City of Portland, Maine – Building or Use Permit Application 389 Congress Street, 04101, Tel: (207) 874-8703, FAX: 874-8716

Location of Construction: 76 Rackleff St		Owner: Whitman, Sally		Phone:		Permit No: 970349 PERMIT ISSUED
Owner Address:		Lessee/Buyer's Name:		Business Name:		
Contractor Name: American Profiles		Address: 20 Blaine St Manchester, NH		Phone: <i>6310-2</i> 03062 1-800-639-7902		Permit Issued: APR 28 1997 CITY OF PORTLAND
Past Use: 1-fam		Proposed Use: Same		COST OF WORK: \$ 2,200.00		
				PERMIT FEE: \$ 30.00		Zone: <i>R-5</i> CBL: 122-D-013 Zoning Approval: <i>OK</i> <i>4/23/97</i> Special Zone or Reviews: <input type="checkbox"/> Shoreland <input type="checkbox"/> Wetland <input type="checkbox"/> Flood Zone <input type="checkbox"/> Subdivision <input type="checkbox"/> Site Plan maj <input type="checkbox"/> minor <input type="checkbox"/> mm <input type="checkbox"/>
				FIRE DEPT. <input type="checkbox"/> Approved <input type="checkbox"/> Denied		
Proposed Project Description: Install Patio Enclosure on existing deck pad				INSPECTION: Use Group <i>R3</i> Type <i>5B</i> <i>BOCA 96</i> Signature: <i>Hoffman</i>		PEDESTRIAN ACTIVITIES DISTRICT (P.A.D.) Action: Ap

INSTALLERS LAYOUT

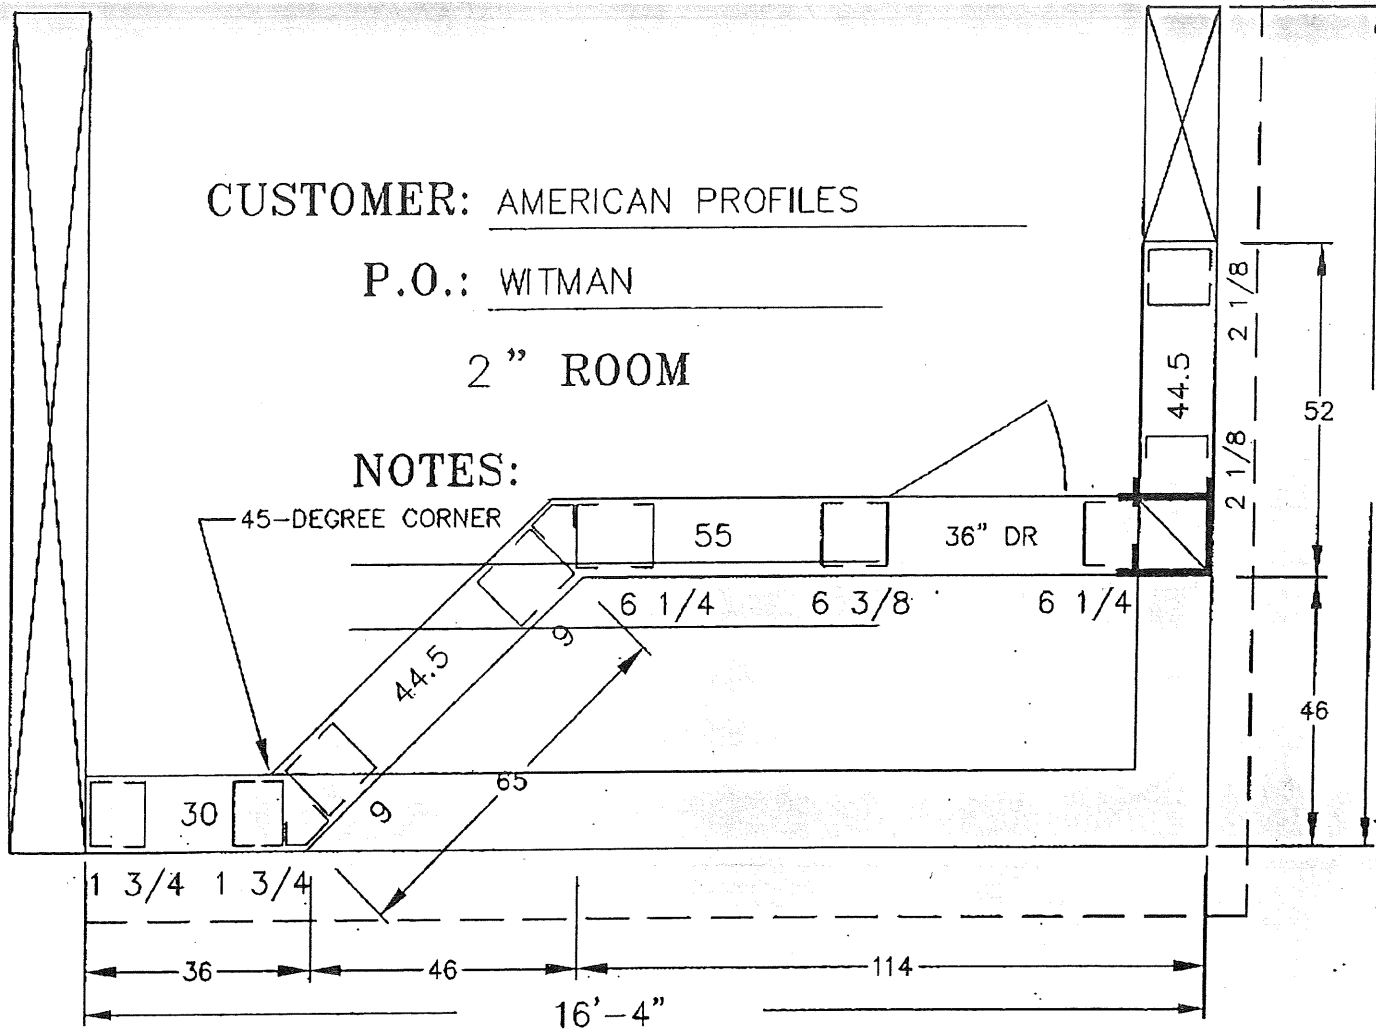
* 25. ~~Before any work begins on this proposed project, a new roof framing detail showing the live load for the roof is 42 PSF NOT the 30 shown on the plan.~~

* 26. ~~The City of Portland requires all building over 100sq. ft. to be placed on a Frost wall or engineered piers. please resubmit this information before work begins.~~
